CITY OF ALBUQUERQUE

RE: **McDonalds – Menaul and San Pedro**
5900 Menaul Blvd NE
Site Plan for Building Permit
(Non-stamped) Plan Date: 5/16/18 (File: H18D070)

Based upon the information provided in your submittal received 6/13/17, the Grading and Drainage Plan cannot be approved until the following are addressed:

POST-DEVELOPED DRAINAGE PLAN

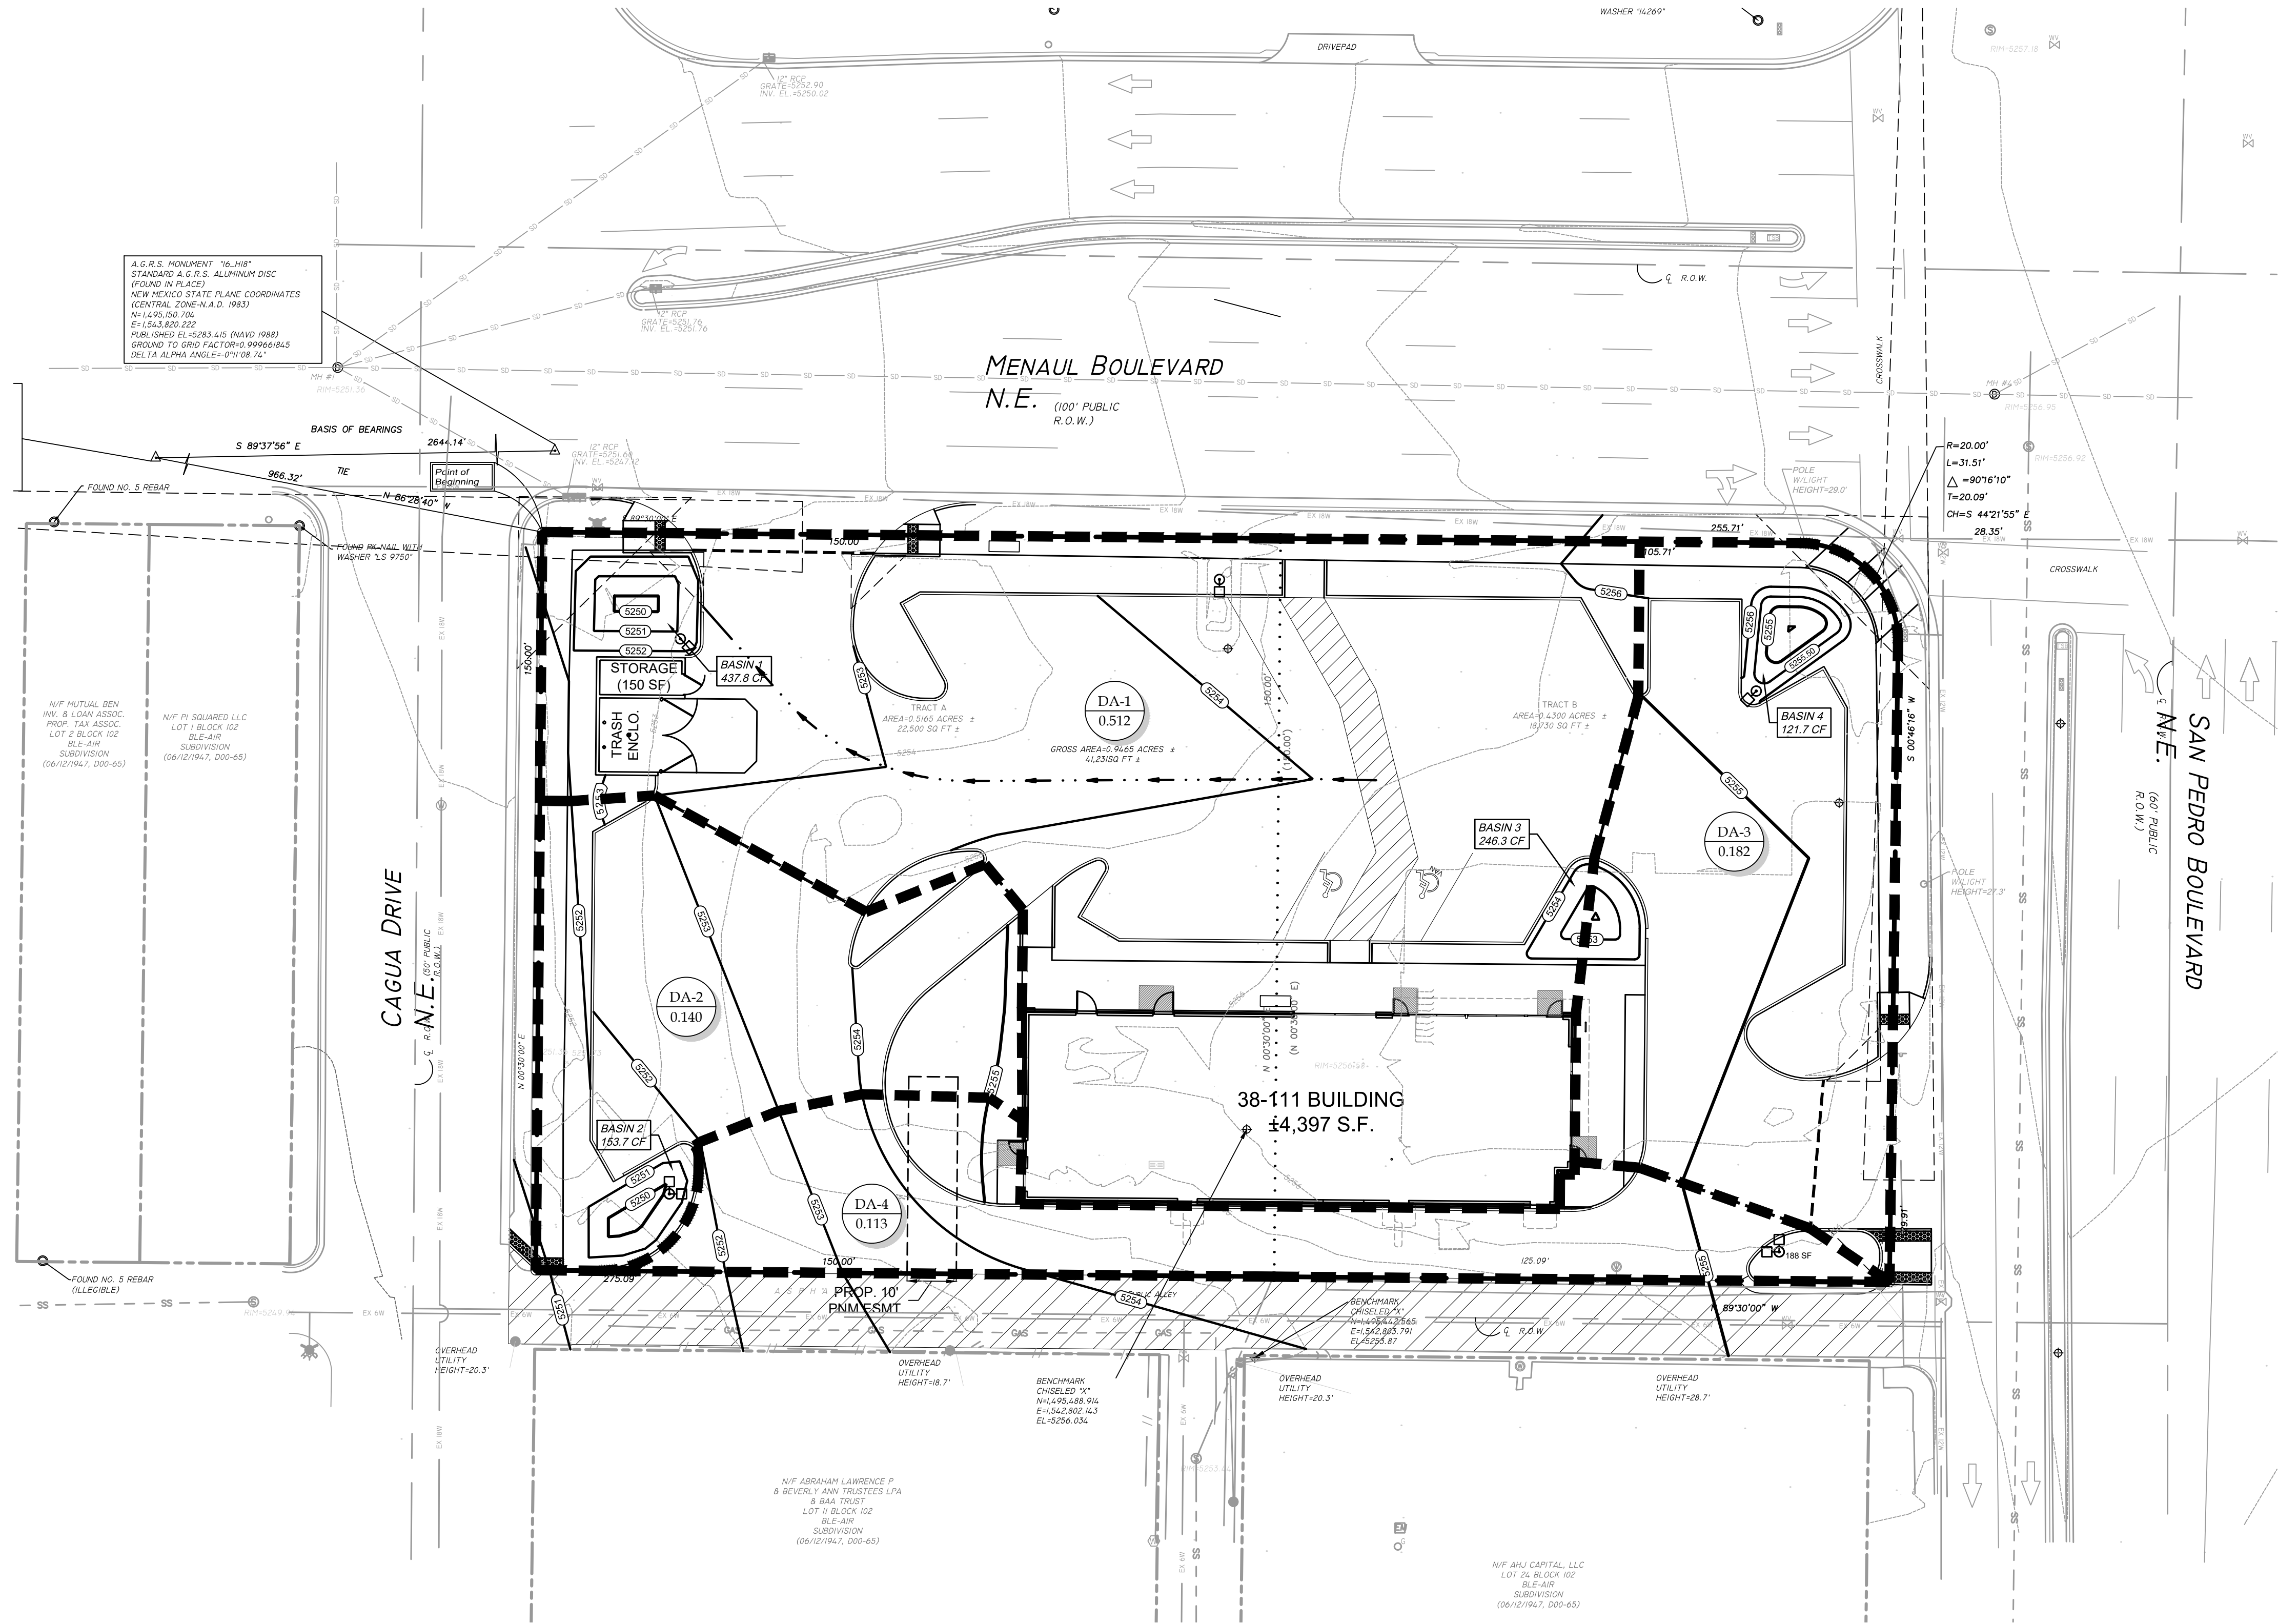
2. This site qualifies as redevelopment and is only required to retain runoff from the 80th percentile storm (Vol. = 0.26”*Imp.Area).
3. If pond 3 cannot be upsized to retain the contributing first flush requirement, payment of Fee-in-Lieu for the bypass volume may be made at a rate of \$8/cf.

4. Basin DA-4 needs to be routed through a first flush pond. Alternatively, payment of Fee-in-Lieu for this bypass volume may be made at a rate of \$8/cf if unable to pond on-site.

5. If selecting the Fee-in-Lieu option for portions of this site, state the bypass volume on plans; payment of the Fee-in-Lieu will then be required at the time of Building Permit.

SITE DEVELOPMENT PLAN
GRADING AND
DRAINAGE PLAN

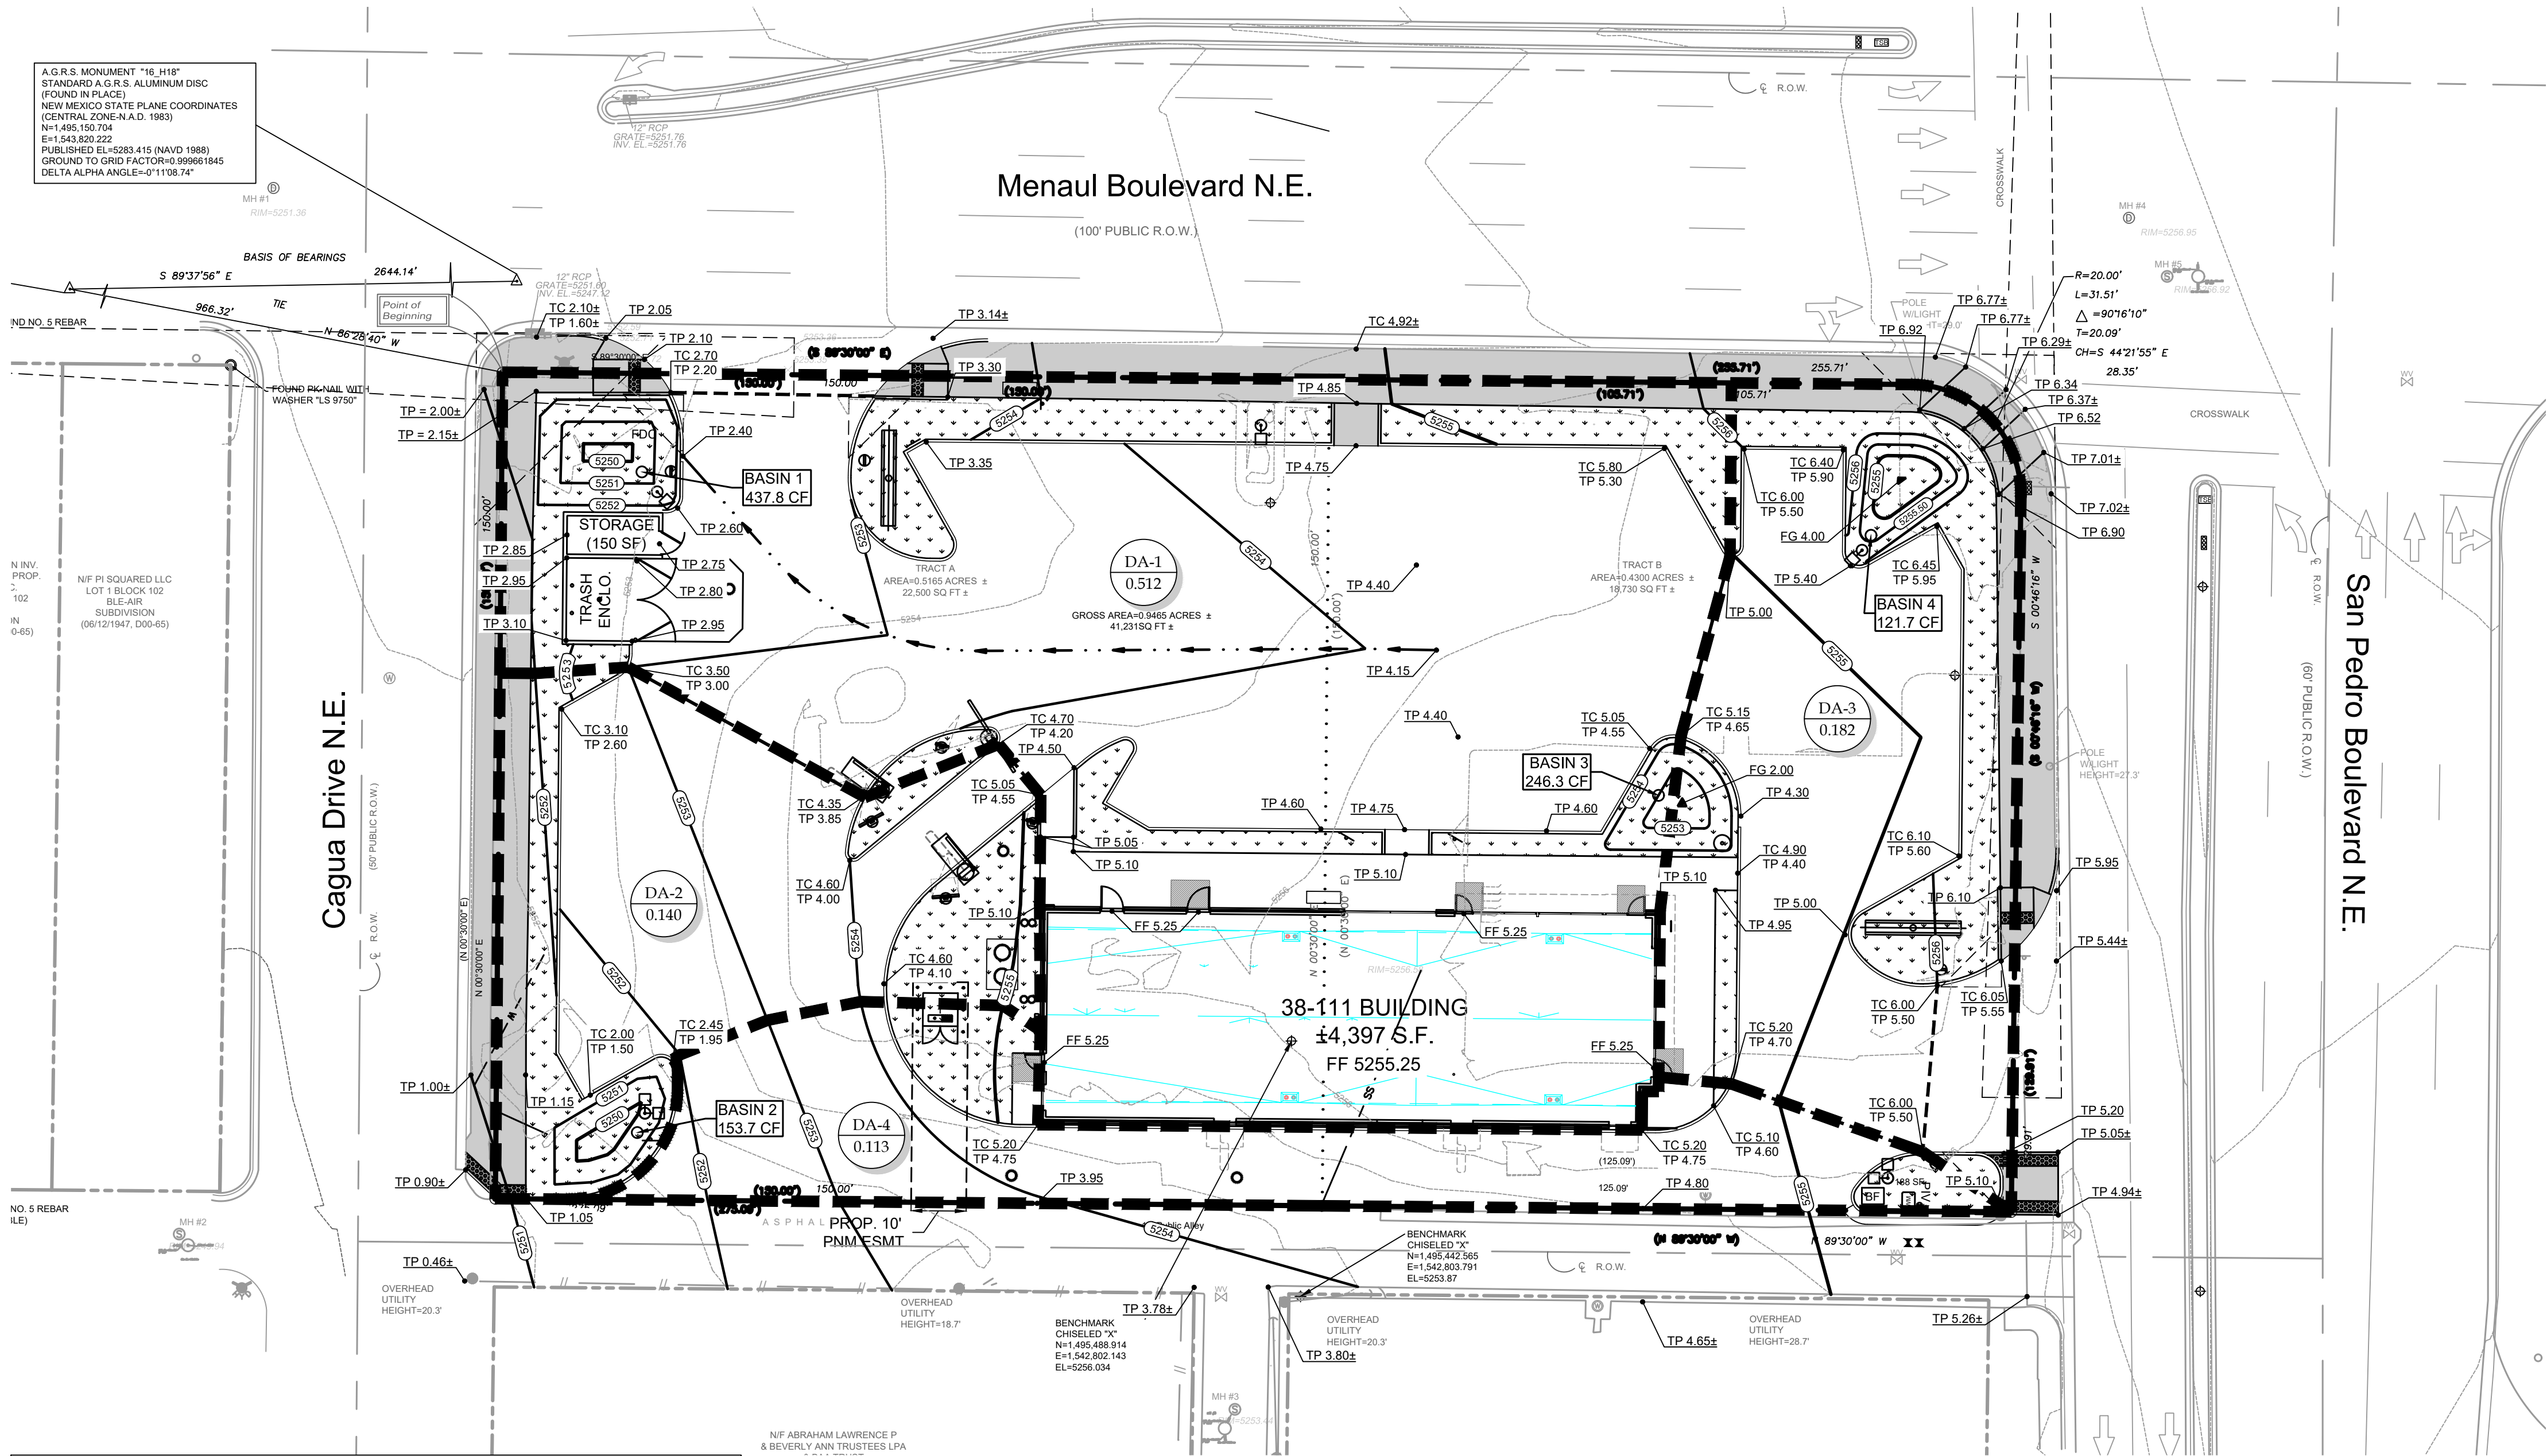
1. How will flows discharge from the ponding areas to the public ROW (sidewalk culverts, tie-in to existing drop inlets)? Discharging across sidewalks is not acceptable.

6. Add note on the plan that “No work shall be performed in the public ROW without an approved Work Order or Excavation Permit.”
7. If only seeking Site Plan for Building Permit approval at this time, label the grading plan “Conceptual, Not For Construction” or similar and address the SPBP comments. If seeking SPBP and Building Permit simultaneously, forgo the conceptual markings and address all SPBP and Building Permit comments.

8. Waterblocks, 12" high from top of pavement on the drivepad to bottom of gutter along the road, need to be incorporated at the San Pedro entrance.
9. This work will require an Erosion and Sediment Control Plan submitted to the storm water quality engineer (Curtis Cherne, PE, ccherne@cabq.gov) before Building Permit Approval.

10. The Grading and Drainage Plan will need to be sealed by the Engineer prior to approval by Hydrology.
11. For trash enclosures serving food service developments, please include a drain line to a grease trap and then drain into the sanitary sewer. If this information is on the utility plan please provide it, or show on the grading plan.
